WOODBURY HULL BOUNDARY ADJUSTMENT

BEING A PART OF THE NORTHEAST QUARTER OF SECTION 28,
TOWNSHIP 11 SOUTH, RANGE 66 WEST OF THE 6TH PRINCIPAL MERIDIAN,
COUNTY OF EL PASO, STATE OF COLORADO.

V1_Final Plat Drawings_COMMENTS.pdf Markup Summary

SHEET 1 OF 3

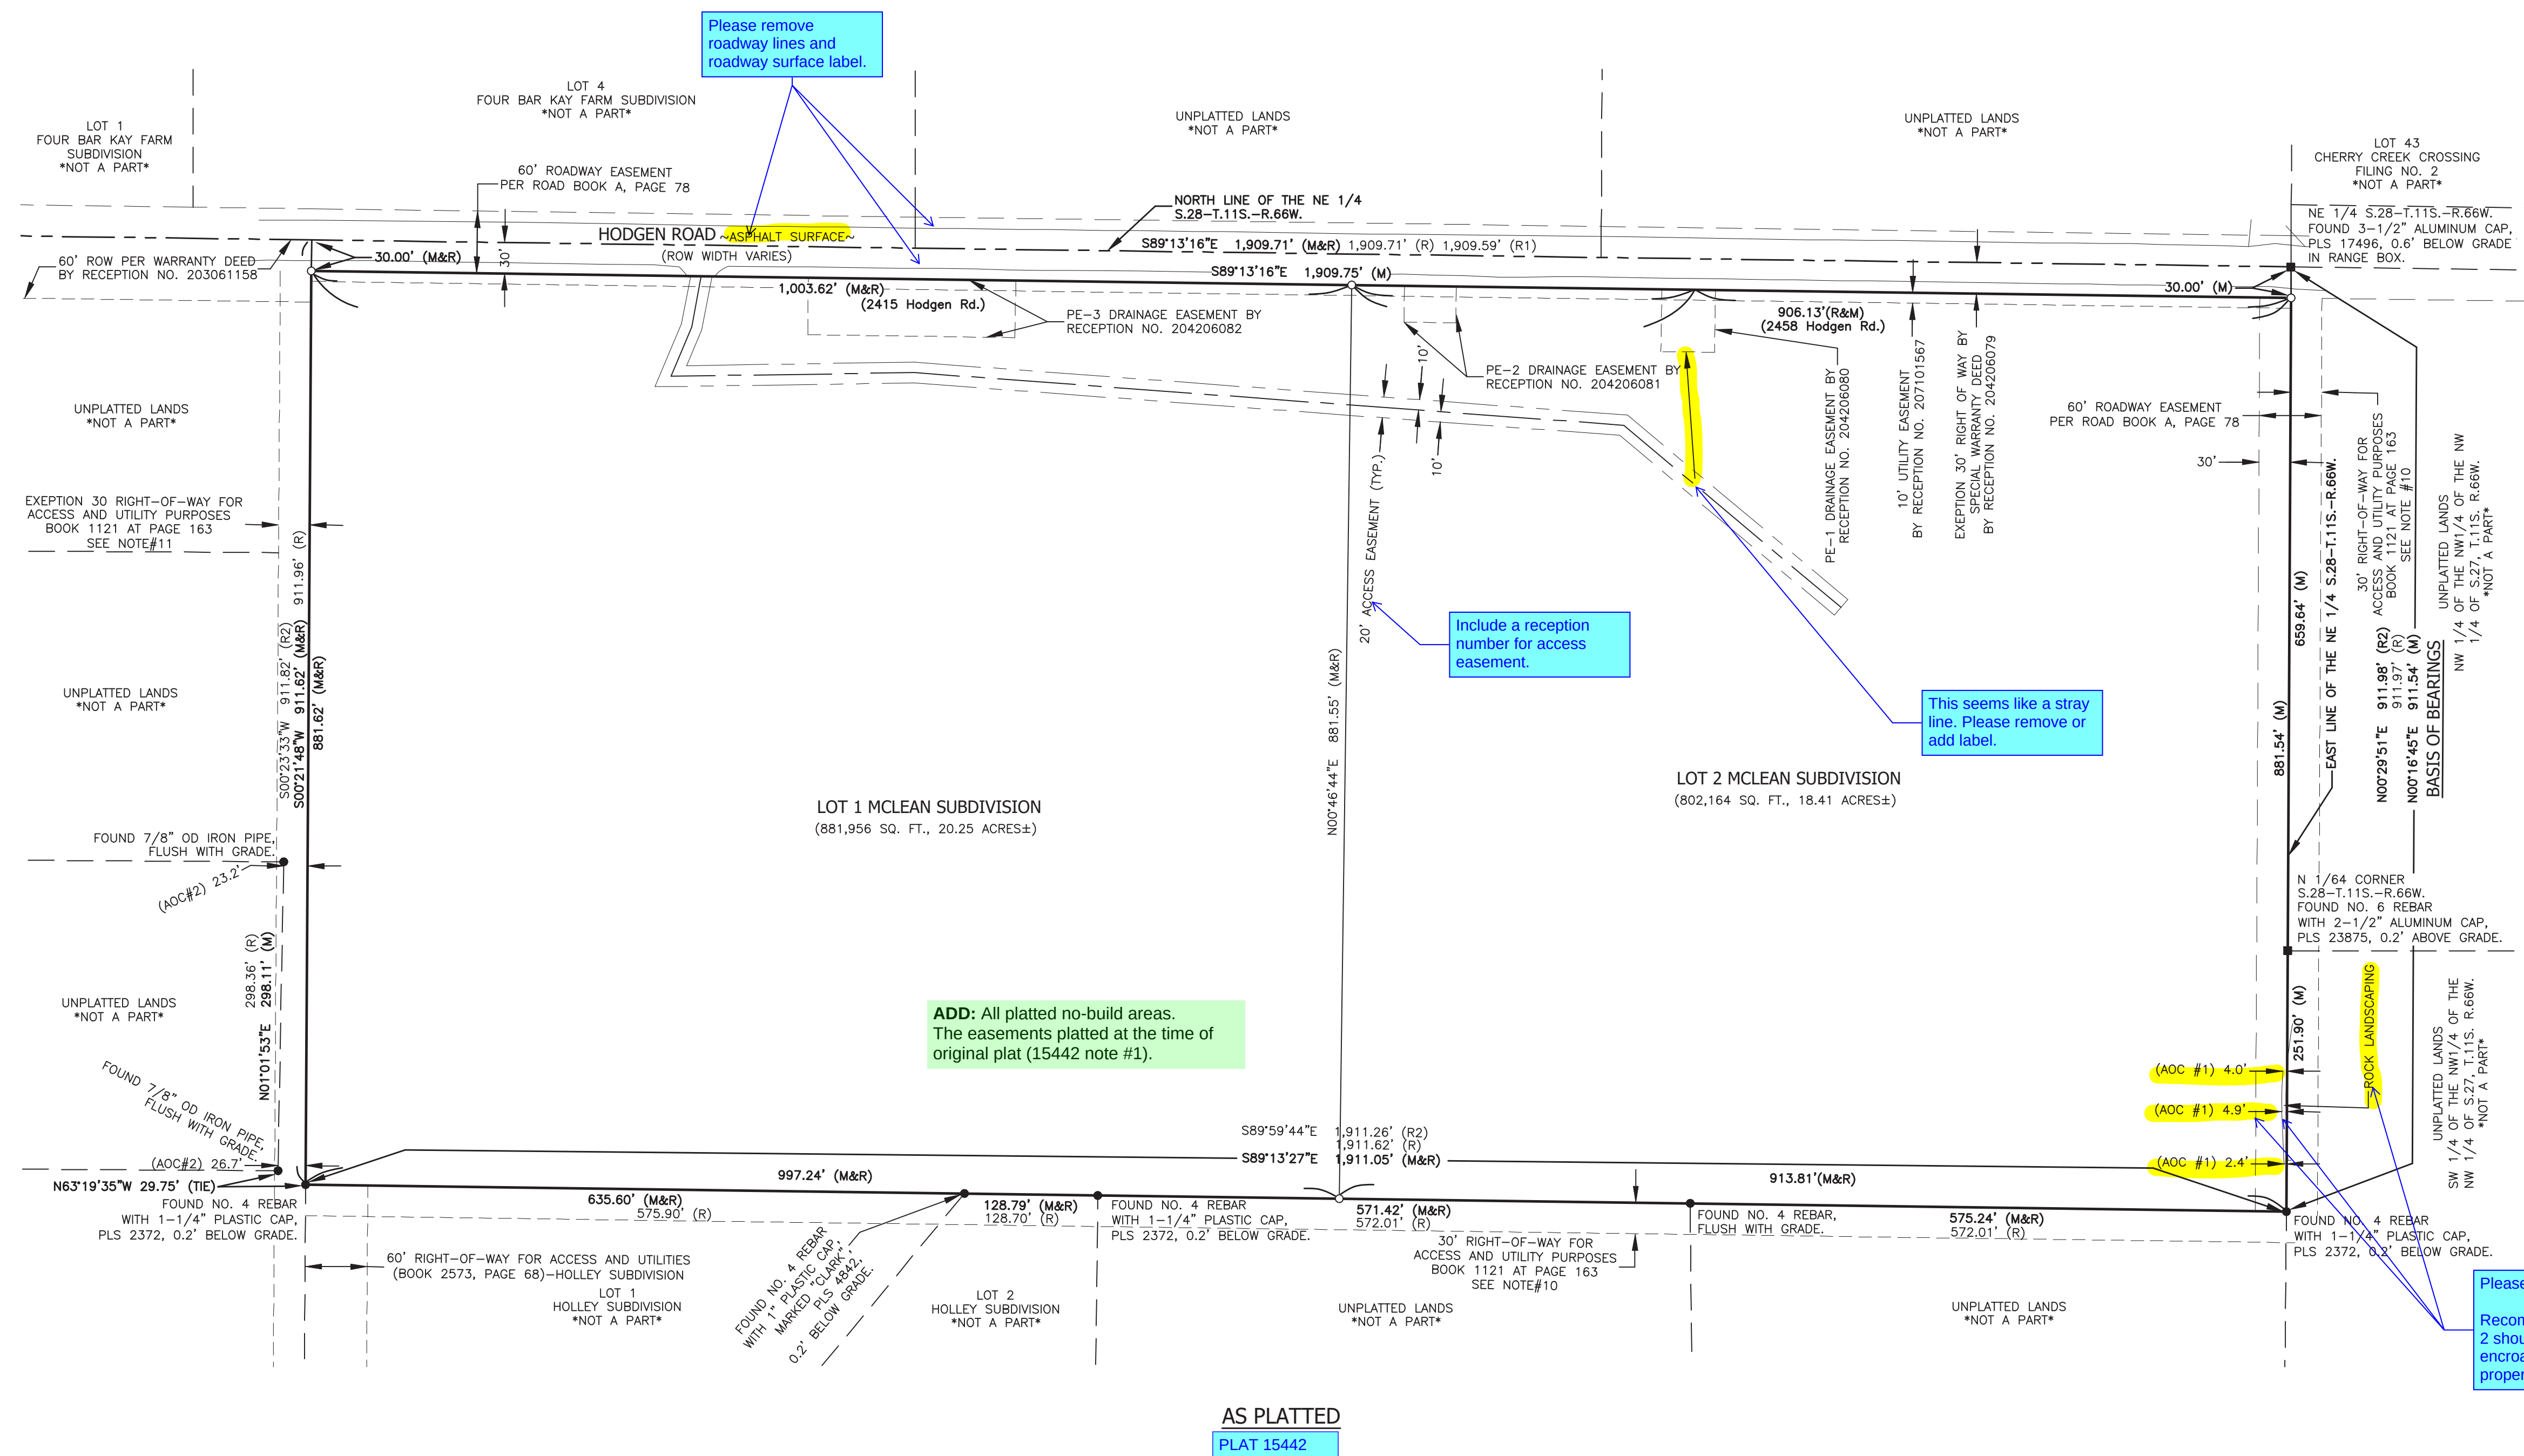
REVISE: Title on all sheets - MCLEAN SUBDIVISION FILING NO. 1A

REVISE: This should say, "A REPLAT OF LOTS 1 AND 2 OF MCLEAN SUBDIVISION", then section, township, range, county, state on all sheets.

All Plat Notes from 15442 need to be carried over to this document.
Title should say "PLAT NOTES"

UPDATE BOTH:

UPDATE:

Please include the following standard notes for engineering, note numbers are referenced to original plat no. 15442.

- Driveway access permit, Note 3.
- Access restriction, Note 7.
- Floodplain, Note 8.
- Stormwater drainage, Note 11.
- Driveway construction, Note 13.

Please include the following note:
The subdivider(s) agree on behalf of him/herself and any developer of builder successors and assignees that subdivider and/or said successors and assigns shall be required to pay traffic impact fees in accordance with the El Paso County Road Impact Fee Program (Resolution No. 25-337), or any amendments thereto, at or prior to the time of building permit submittals. The fee obligation, if not paid at final plat recording, shall be documents on all sales documents and in plat notes to ensure that a title search would find the fee obligation before sale of the property.

Please include a note stating the maintenance responsibility of the access easement (i.e. Lot 1A, Lot 2A or both).

ADD THIS SIGNATURE BLOCK:

This plat for MCLEAN SUBDIVISION FILING NO. 1A was approved for filing by the El Paso County, Colorado Planning and Community Development Department Director on the _____ day of _____, 20____, subject to any notes or conditions specified hereon.

Previous plat name in entirety is amended for the areas described by this Lot Line Adjustment subject to all covenants, conditions, and restrictions recorded against and appurtenant to the original plat recorded in the Office of the El Paso County Clerk and Recorder, Reception # 224715442.

PAGE 2 OF 3

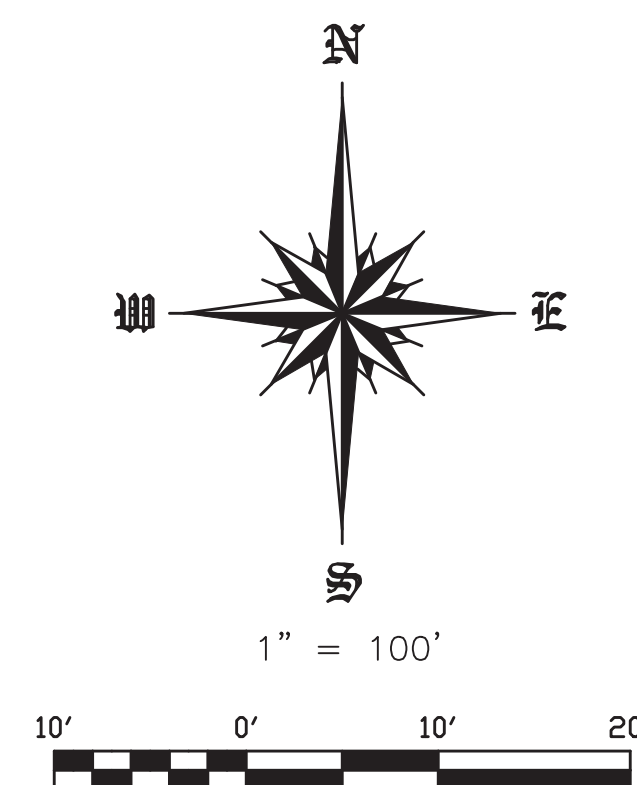
Many engineering comments apply to both this sheet and the next one.

See comment on Page 1.

20' ACCESS EASE
Include a reception number for access easement.

Include a reception number for access easement.

Please remove roadway lines and roadway surface label.

Please remove from plat drawing.

Recommend that the owner of Lot 2 should discuss landscaping encroachment with the adjoining property owner.

This seems like a stray line. Please remove or add label.

SHEET 3 OF 3

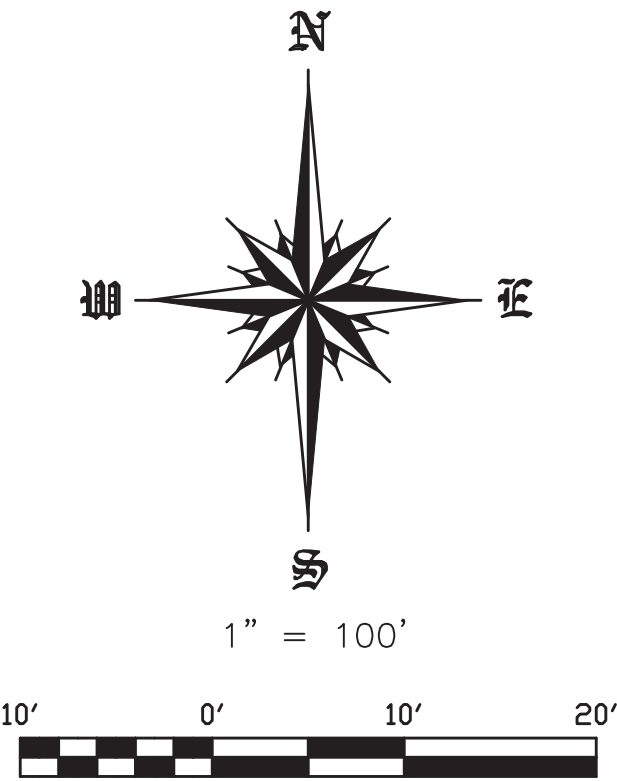
The El Paso County 2045 Major Transportation Corridors Plan depicts the Hodgen Road classification as a minor arterial roadway with planned improvements. EPC is requesting an additional 20' of Right of Way preservation (reserving the land for the County to purchase from property owners in the future) to accommodate planned improvements. If the applicant wishes to preserve 20' of Right of Way in response to this request, please depict on this drawing.

It isn't very clear what some of the dimensions are referring to (2 examples highlighted). Please revise for clarity.

ADD: All platted no-build areas. The easements platted at the time of original plat (15442 note #1).

Remember to remove "DRAFT" for next submittal.

CORRECT: LOT 1A

CORRECT: LOT 2A
